# Flair Spectrum Specific Plan

Flair Spectrum Specific Plan  
Final Environmental Impact Report

## Response A – Cathay Bank

## Comment B – California Department of Transportation, District 7

Exhibit A  
**Flair Spectrum Intersection Impacts in the  
Vicinity of the El Monte Cathay Bank**

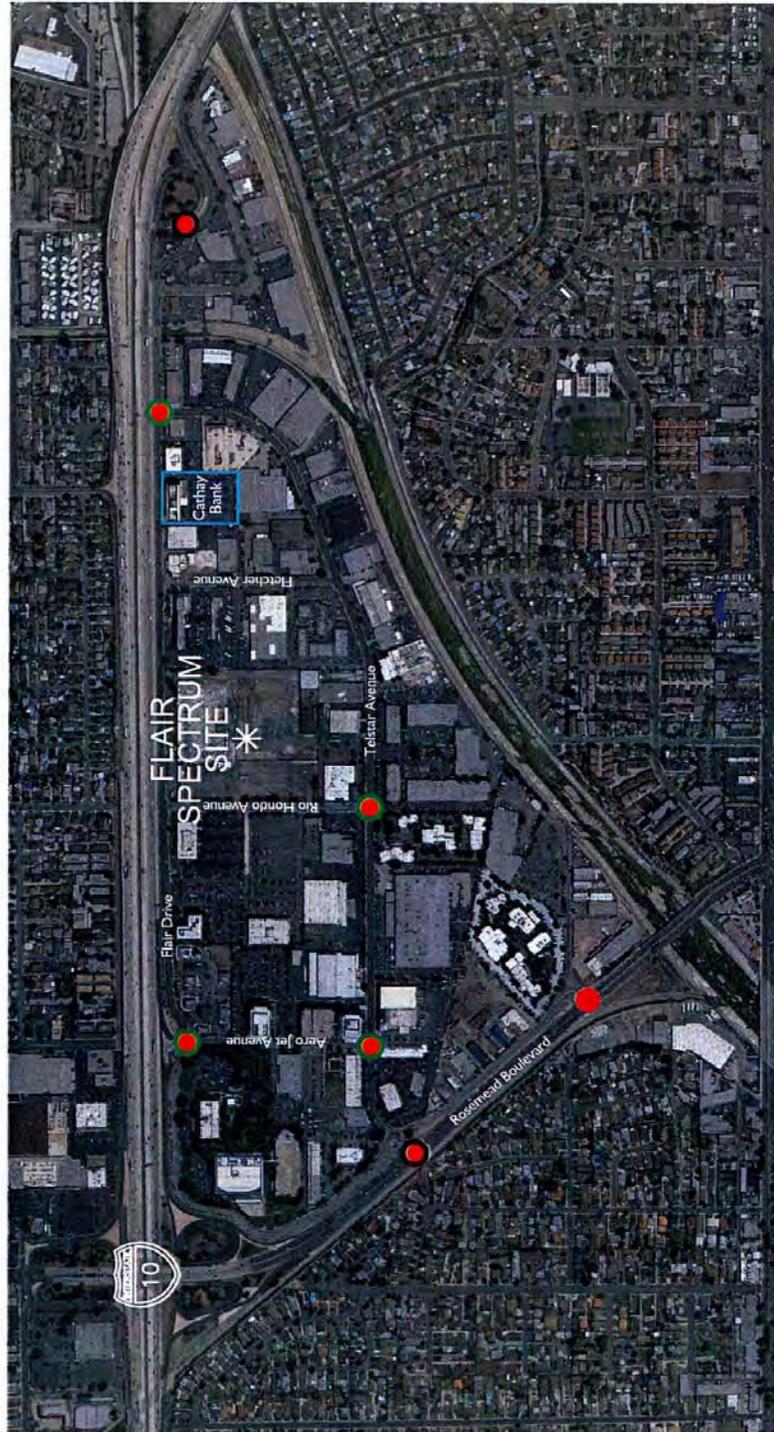
A detailed draft EIR and traffic study has been prepared for the project. The traffic study, prepared by Linscott, Law and Greenspan (dated October 22, 2014), analyzed 46 intersections in the vicinity of the site. The study identified several significant traffic impacts within close proximity of the Cathay Bank. The study area is shown within Appendix A (figure 1-1) and the yellow highlighted area is the area which would most significantly impact traffic conditions around the Cathay Bank. The traffic study has identified significant traffic impacts in the area and identified mitigation measures that are required to be implemented to ensure acceptable levels of service in the area. RK's traffic review revealed three areas of major concern with respect to the development and the implementation of the mitigation measures. These include:

- A-3 The commenter is correct in noting that some of the mitigation measures and identified improvements (e.g., at Intersection No. 24: Baldwin Avenue/Flair Drive – I-10 Eastbound Ramps and Intersection No. 7: Rosemead Boulevard/Telstar Avenue) are not guaranteed to be implemented in conjunction with the proposed project. For informational purposes, it is important to note that Intersection No. 24 (Baldwin Avenue/Flair Drive – I-10 Eastbound Ramps intersection) is currently operating at Level of Service F (LOS F) conditions under all peak hours (i.e., under weekday AM peak hour, weekday PM peak hour, and weekend [Saturday] mid-day peak hour conditions). This location has also been recognized in the City's General Plan traffic study (prepared in 2010) as operating under LOS F conditions during both the weekday AM and PM peak hour conditions.

## Exhibit B Flair Drive Average Daily Traffic

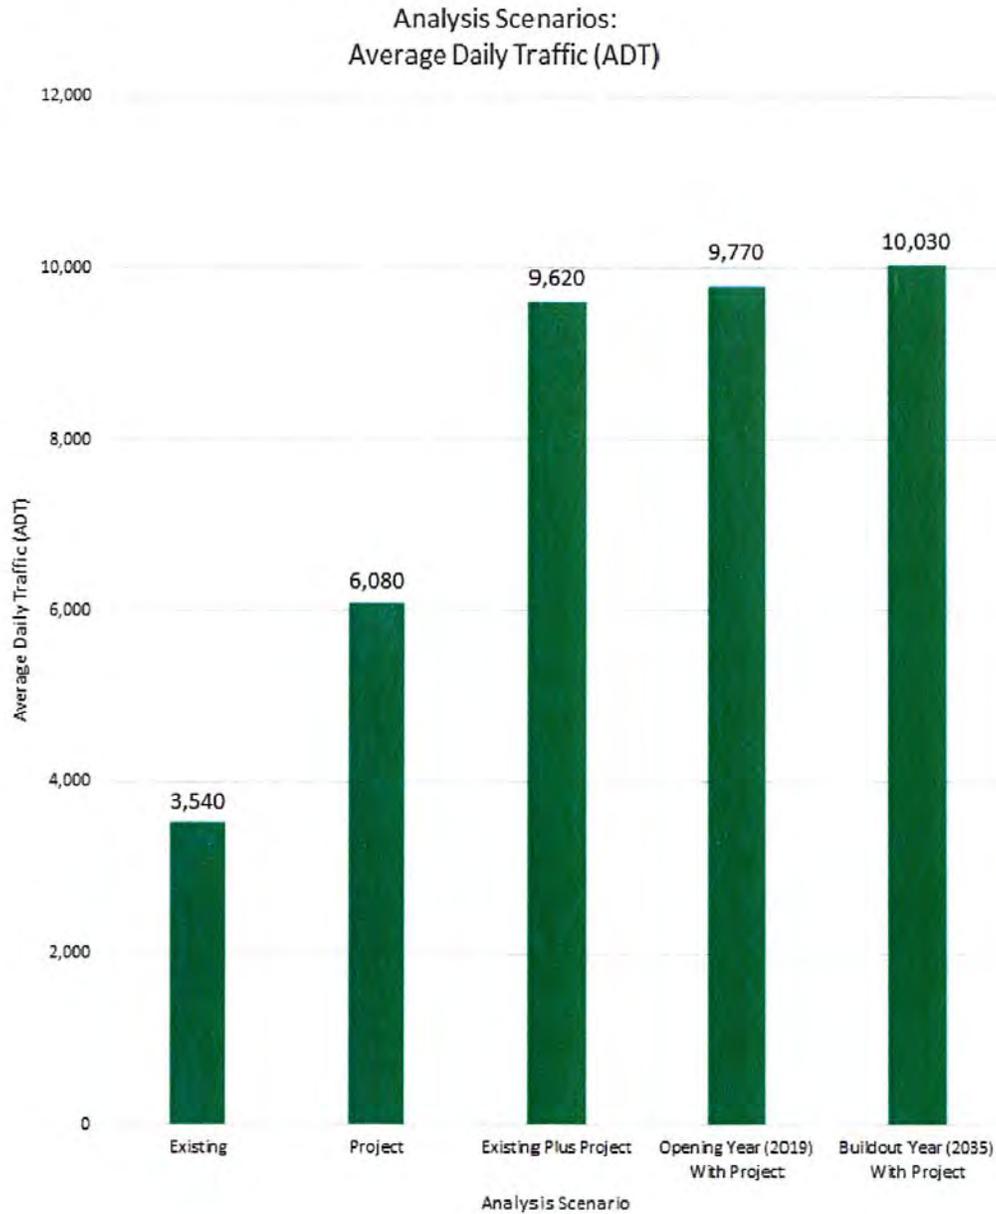
Traffic on Flair Drive with the Flair Spectrum project will increase substantially based upon data included in the traffic study. The existing traffic adjacent to the Cathay Bank is approximately 3,540 ADT (Average Daily Traffic). The Flair Spectrum project will contribute over 30% of its traffic to the east along Flair Drive adjacent to the Cathay Bank. This would add an additional 6,080 ADT to Flair Drive for a total traffic of 9,620 ADT. For Year 2019 with the project, this would increase to approximately 9,770 ADT and for Year 2035 with the project over 10,000 ADT. The estimated average daily traffic is shown in Exhibit B.

Some mitigation needs to be implemented along Flair Drive to ensure it will operate in an acceptable manor from Rosemead Blvd to Baldwin Avenue. This may require the implementation of left turn lanes and other existing striping modifications to accommodate this level of traffic. It should be noted that currently parking is available along some locations along Flair Drive and is critical to the operation of several of the businesses including Cathay Bank. Therefore, eliminating all parking is not a viable solution at every location. The project needs to come up with design solutions for Flair Drive to accommodate the projected Average Daily traffic anticipated with the Flair Spectrum project

- A-7 Some of the comments are introductory in nature and no further response is necessary. The commenter is generally correct in referencing the forecast daily vehicle trip generation expected with the proposed project. As a point of clarification, as noted in Figures 8-1, 8-2 and 8-3, on pages 57, 58, and 60 of Appendix G of the Draft EIR, the project traffic distribution on Flair Drive near Cathay Bank (east of Fletcher Avenue) was assumed at 31%, 30% and 34%, for the hotel, commercial (outlet and restaurant) and residential (condominium) components of the proposed project, respectively. The three-fold increase in average daily traffic (ADT) volume due to the project as referenced by the commenter is significantly overstated. With the existing ADT along this portion of Flair Drive estimated at 3,540 vehicle trips and the proposed project calculated to result in an increase of 6,534 ADT (i.e., applying the above land use distribution percentages to each of the project ADT forecasts per land use component), the increase in ADT due to the project relates to a less than two-fold increase in ADT. The actual increase in existing ADT due to the proposed project is less than a 200 percent increase, or less than two-fold increase (i.e.,  $6,534 \text{ average daily vehicles} / 3,540 \text{ average daily vehicles} = 185 \text{ percent increase}$ , or less than 200 percent or doubling of ADT). The commenter inadvertently miscalculated the increase by including the existing average daily traffic volumes in the proposed project ADT increase calculation (i.e.,  $(3,540 + 6,534) / 3,540 = a \text{ 285 percent increase}$ , and stating an almost three-fold increase). *This comment does not identify any significant new and no further response is required.*

- A-20** Refer to Response A-7 for a full discussion of the Flair Drive average daily traffic volume (ADT) and the clarification that the ADT traffic volume increases due to the proposed project is less than a 200 percent increase, or less than two-fold increase (i.e., 6,534 average daily vehicles / 3,540 average daily vehicles = 185 percent increase, or less than 200 percent or doubling of ADT). The commenter inadvertently miscalculated the increase by including the existing average daily traffic volumes in the proposed project ADT increase calculation (i.e., (3,540 + 6,534) / 3,540 = a 285 percent increase, and stating an almost three-fold increase).
